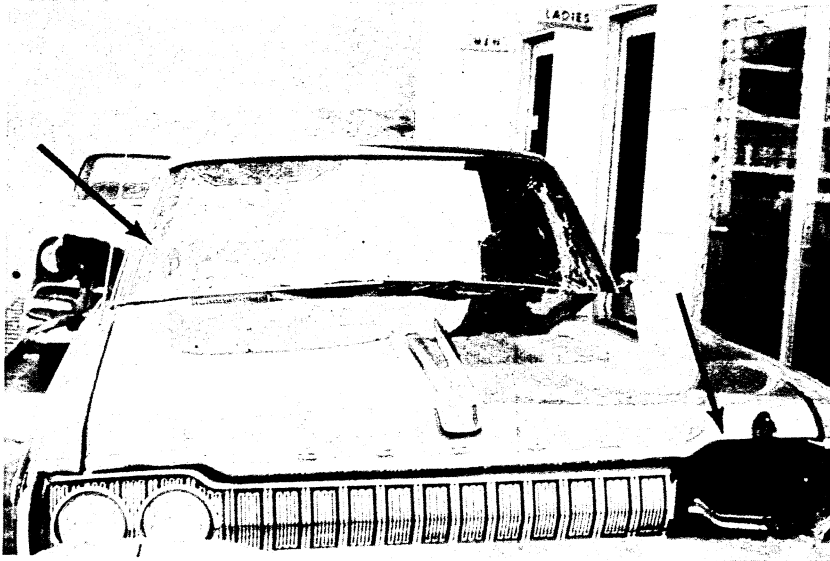
When are we going to learn? Here, they tapered the box beam rail down to the ground which is what they should do ordinarily, but not at this location. If you drive along this rail, you are going to hit this base.
